Moser Pass At Denali Final Development Plan

REQUEST: The applicant is seeking approval of final development plan and final plat by demonstrating compliance with all conditions of approval that are specifically required. This submittal specifically addresses the incompleteness items included in the October 24, 2023, incompleteness letter.

II. INCOMPLETENESS LETTER ITEMS

CONTINUATION SEE E1.1

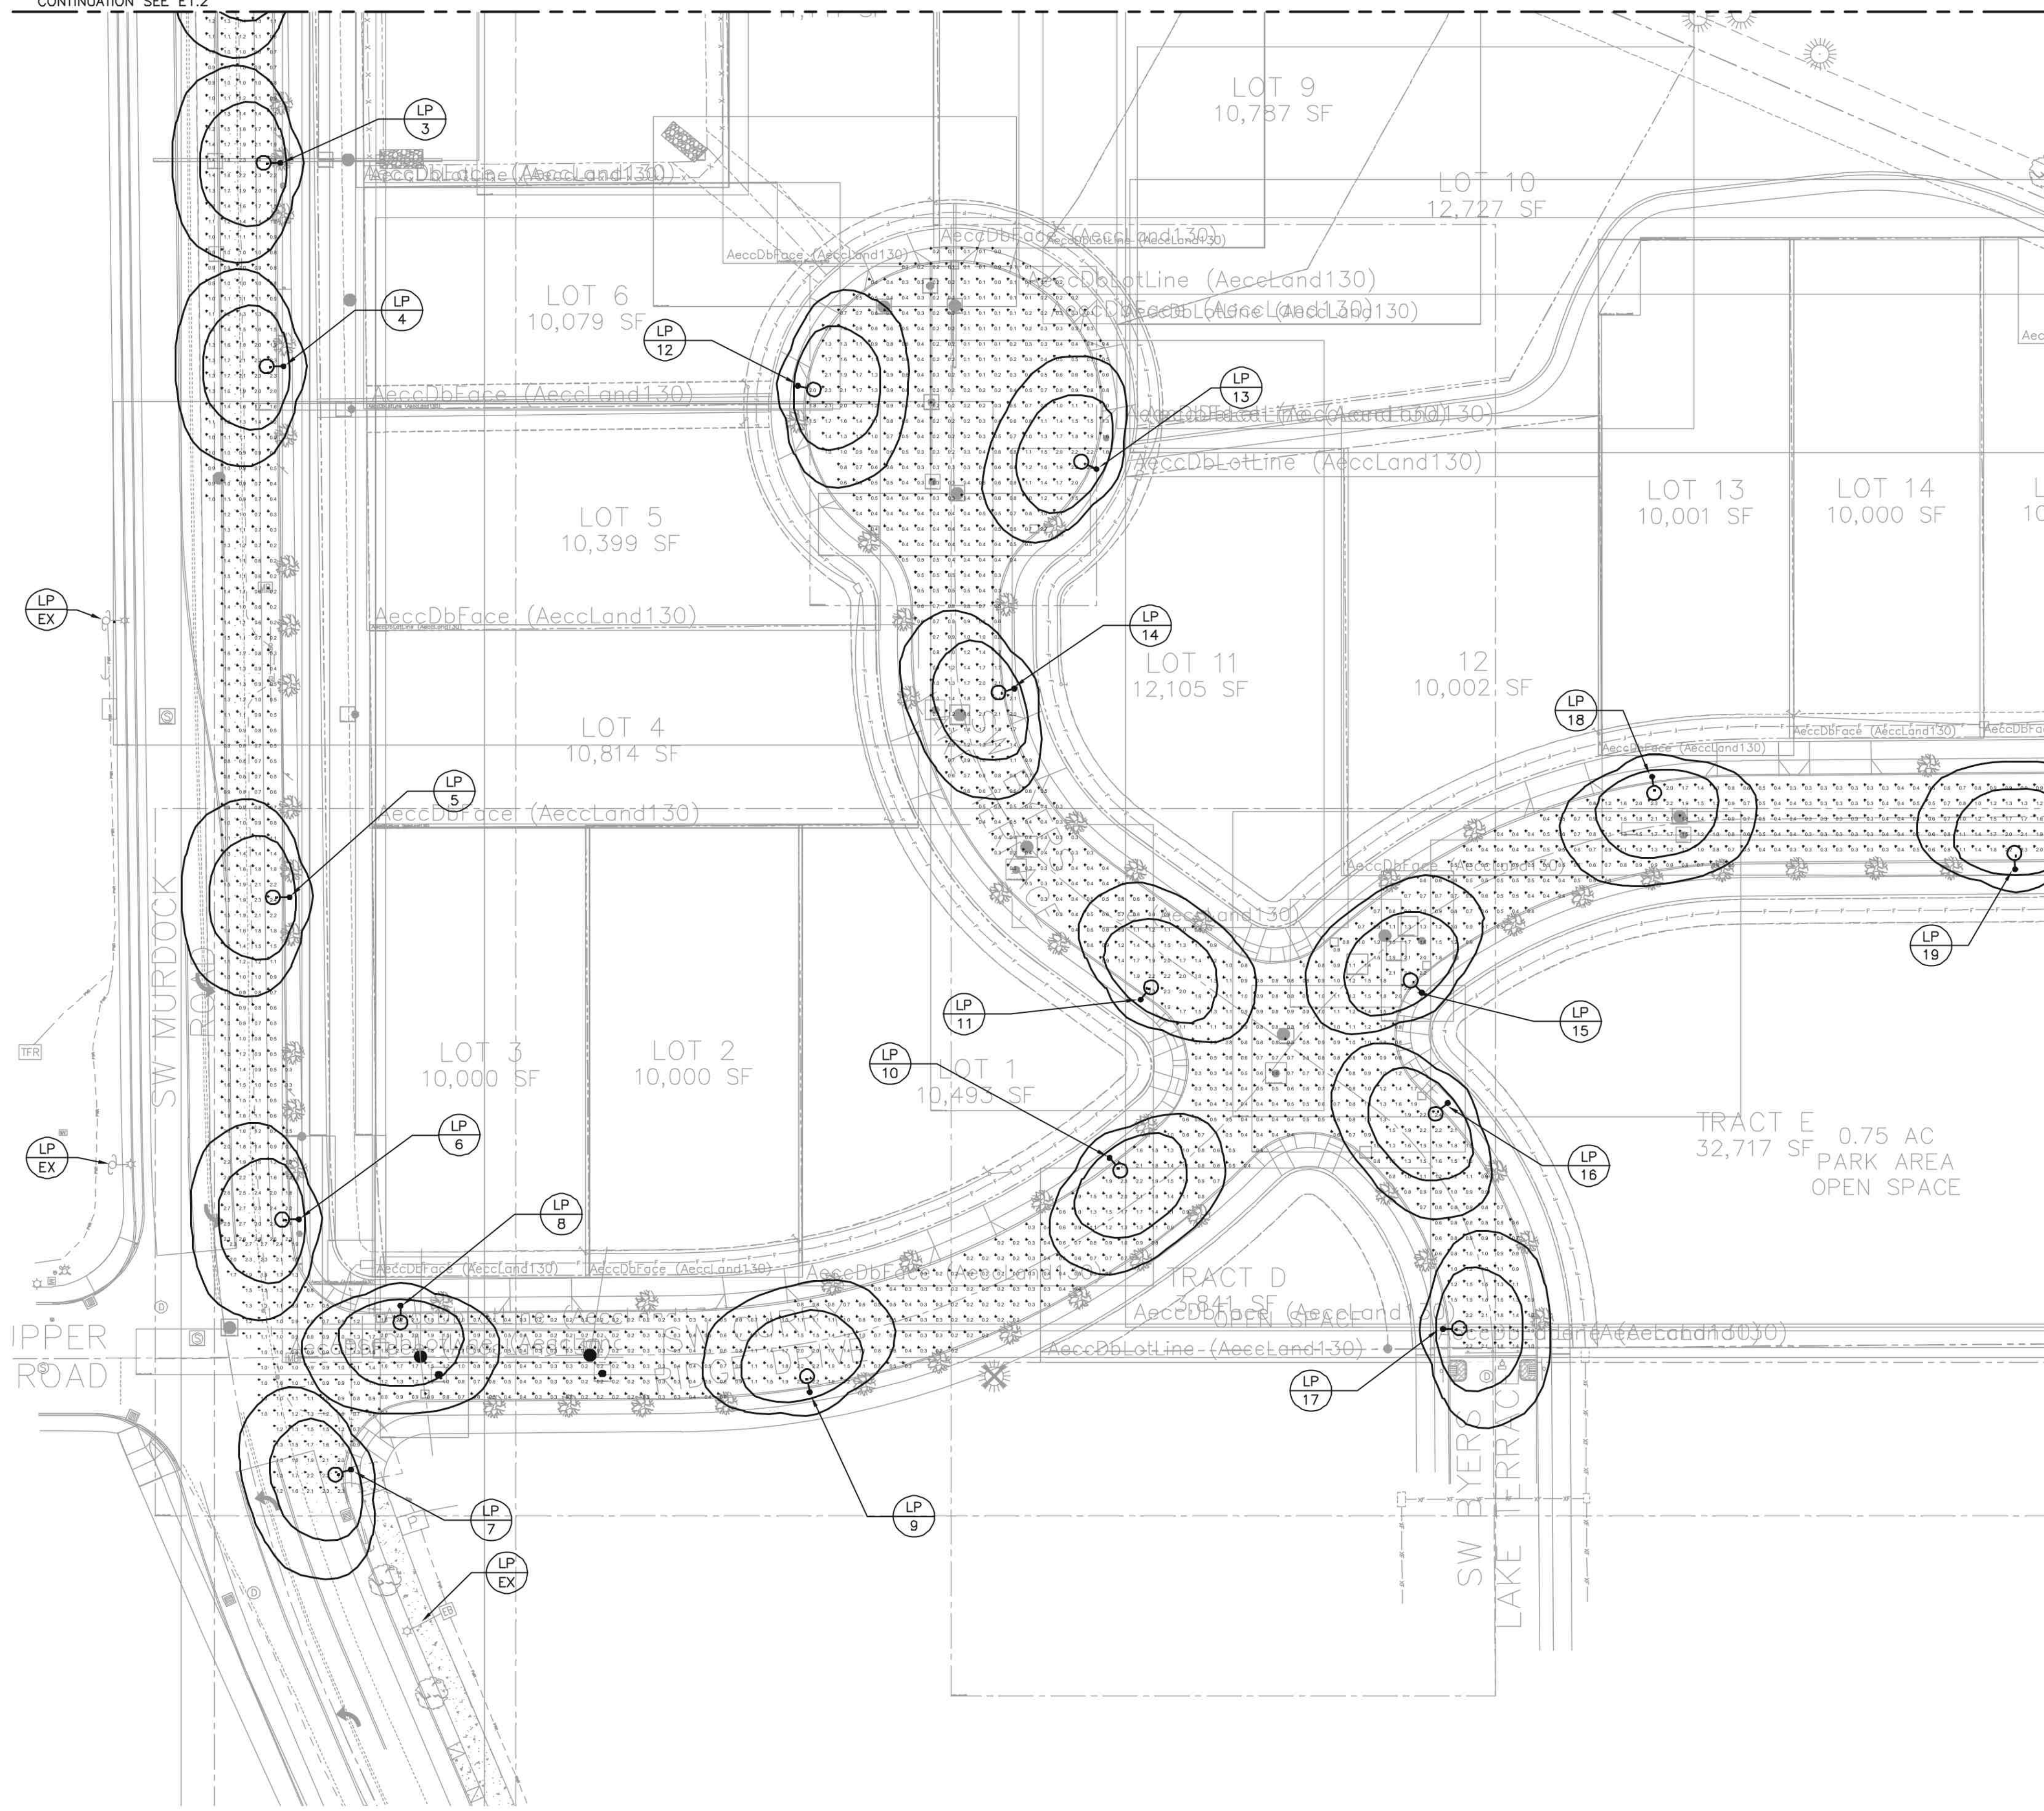
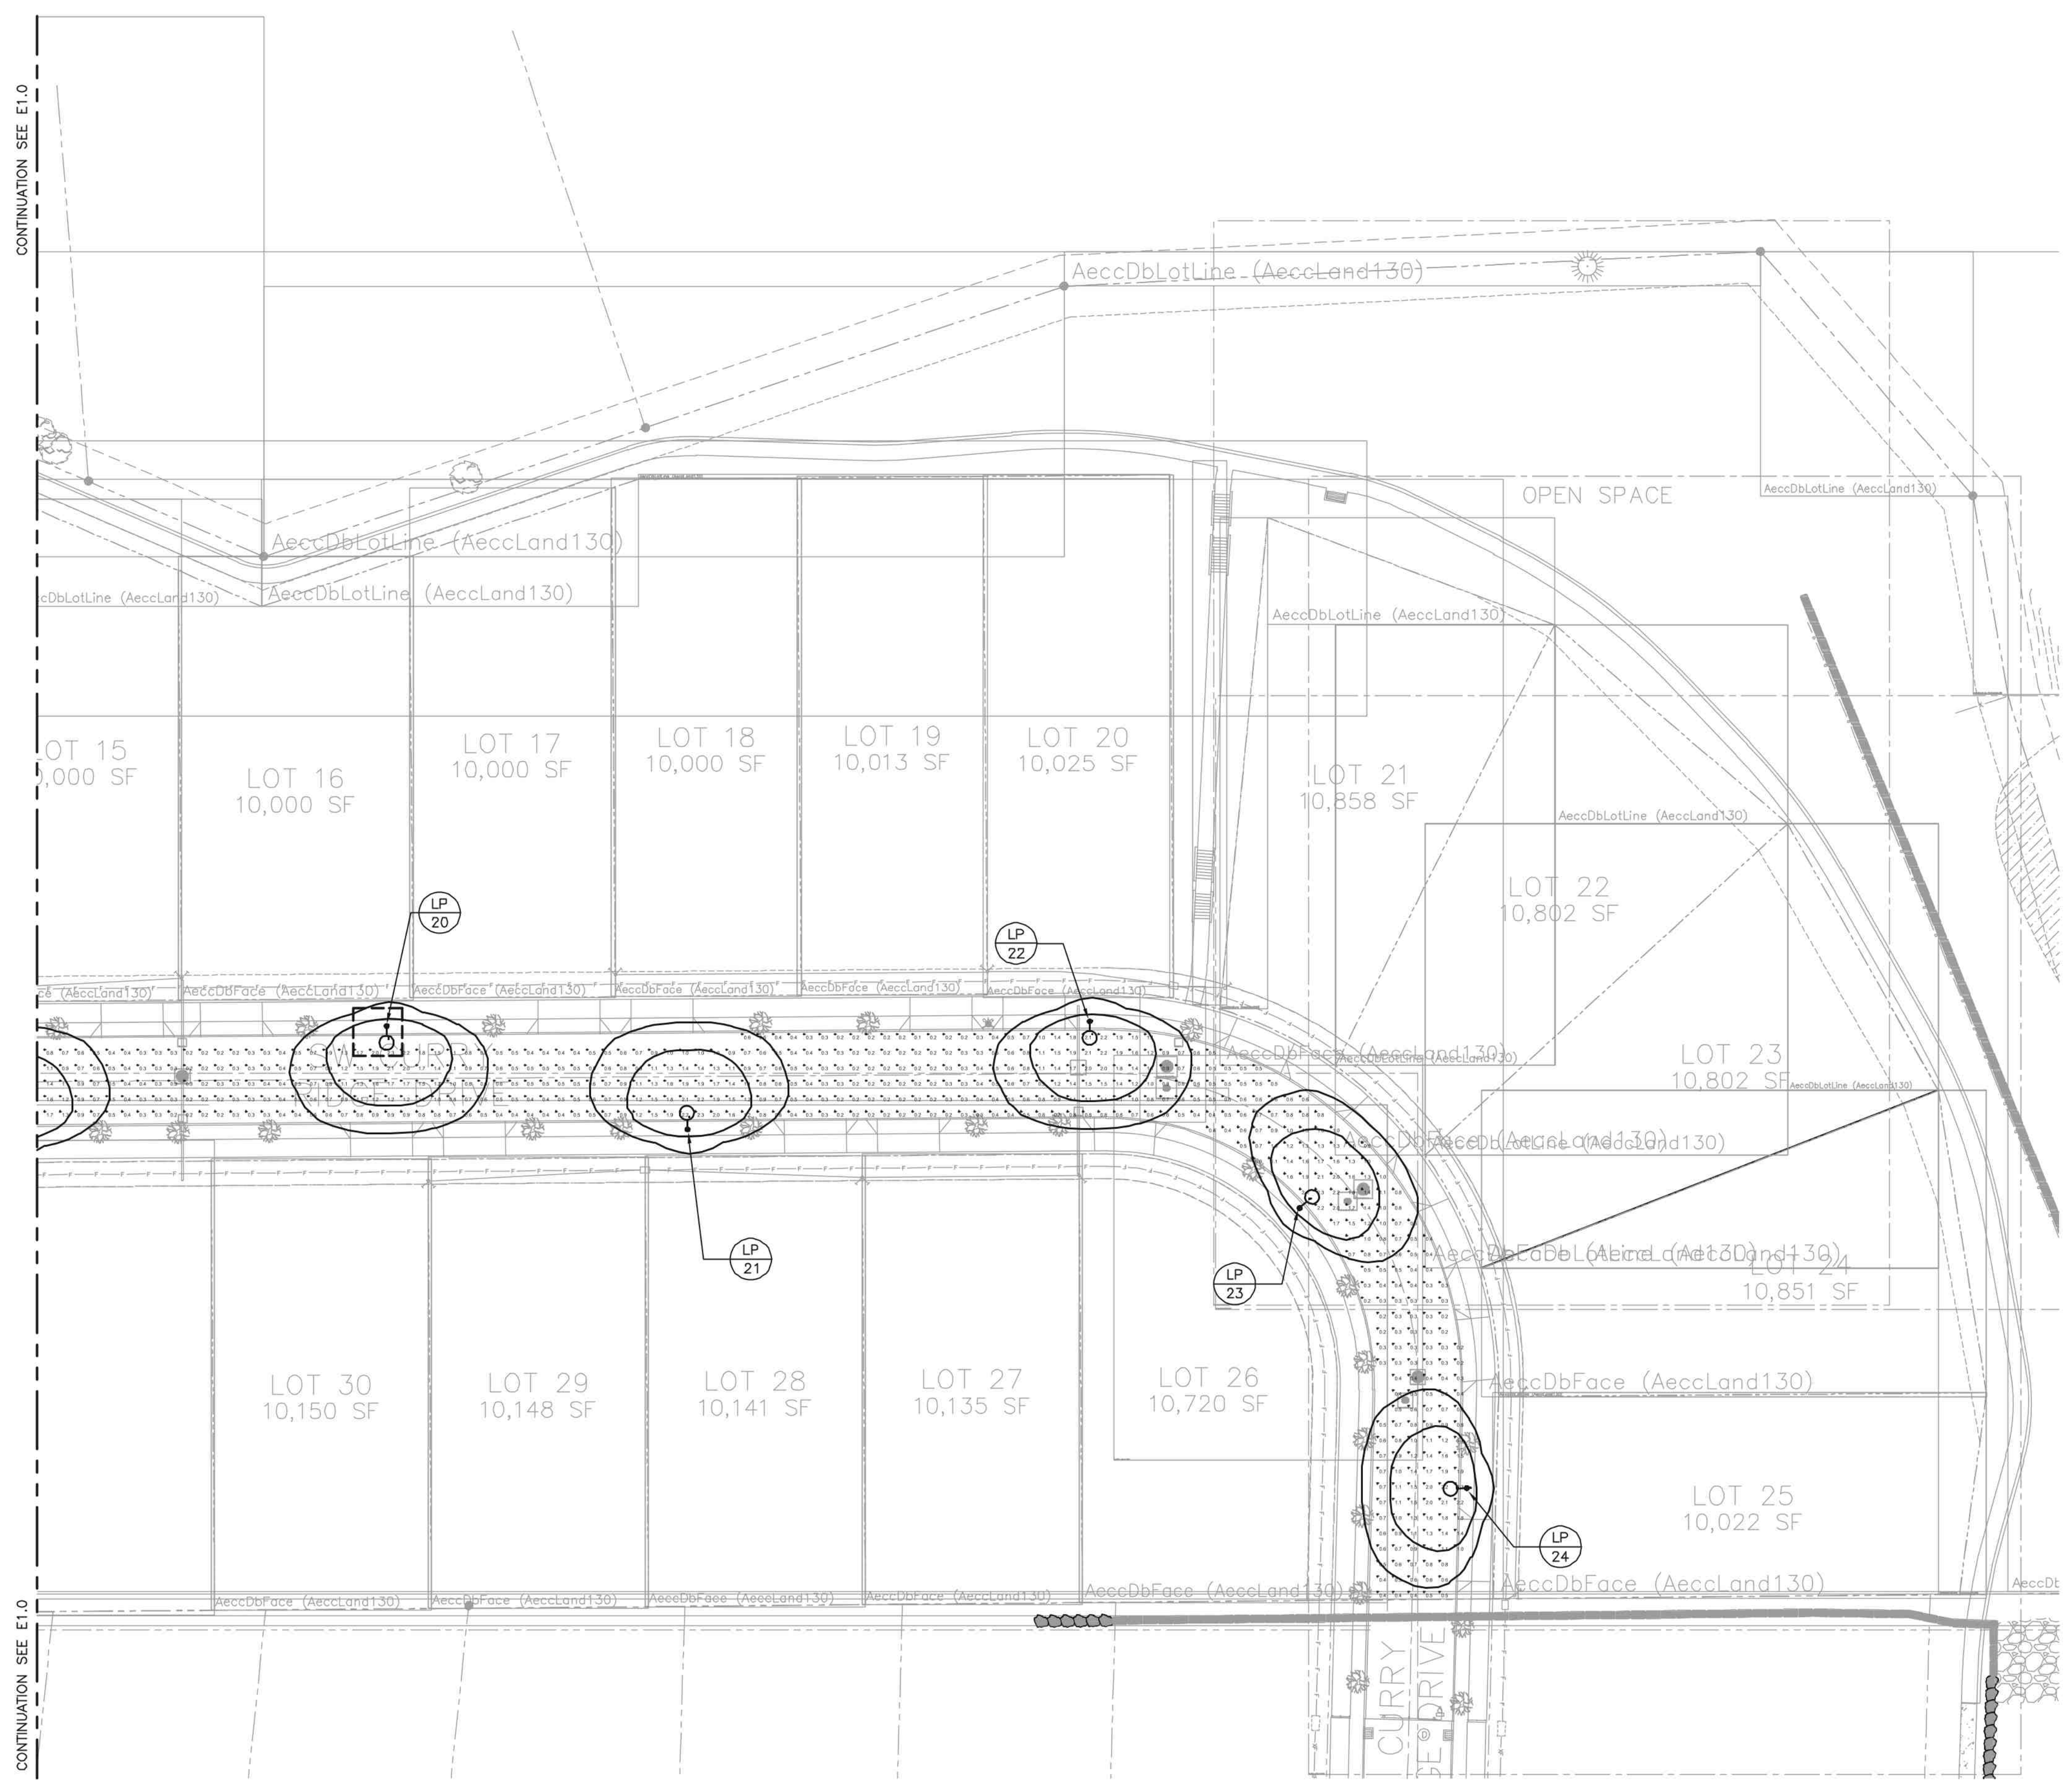
Submit a lighting plan.

Applicant Response: The lighting shown on the park plan exhibit (Exhibit D) is consistent with the submitted lighting plan to address the comment above. The applicant has removed the bocce ball court and horseshoe pits from the plan and has replaced those facilities with a basketball court to meet the desire of the City. The gazebo is shown to have an 'interior' area of 600 sf, includes a picnic table and lighting (lighting also reflected in the submitted lighting plan). The restroom detail has been added for reference and remaining Public Works conditions are ongoing.
